University Community Plan Update Subcommittee

Final Report to the University Community Planning Group on the Community Discussion Draft of the University Community Plan

June 30, 2023

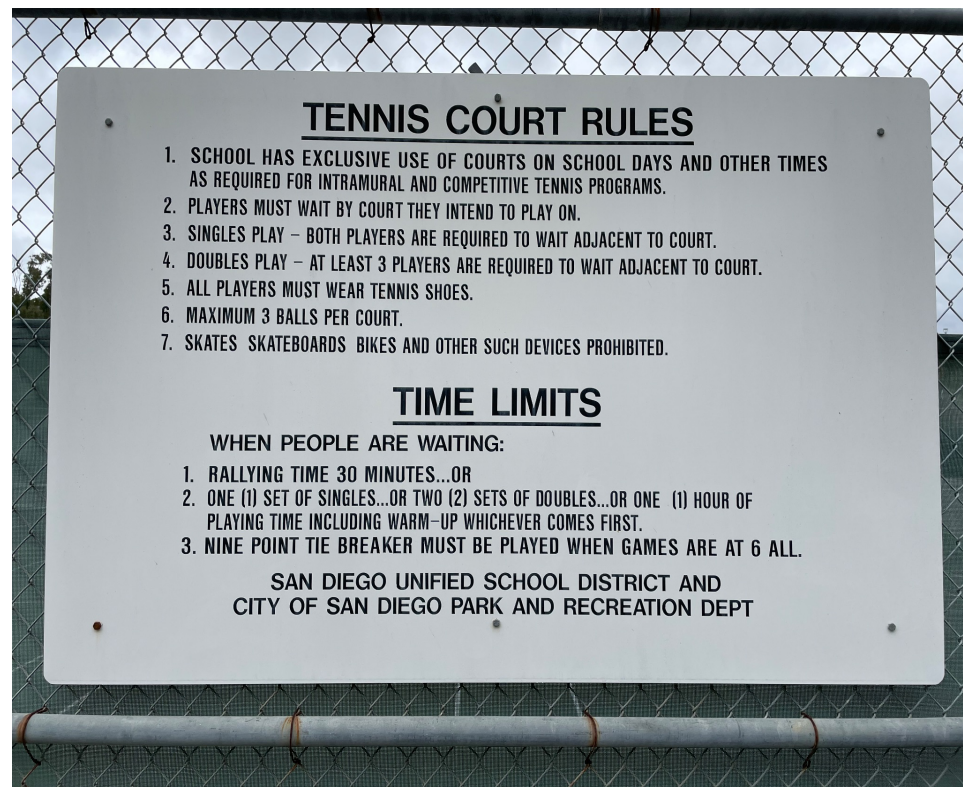
- **Delete recommendation for sports field lighting** as this property adjoins the MHPA and a steep, unlighted canyon visible from I-5, etc. Avoid light pollution and habitat impacts.

- **Revise recommendation:**

“Work with the community to determine items needed and desired to be added to the park. Include on that list for consideration items on the city’s Parks Unfunded Improvements list.”
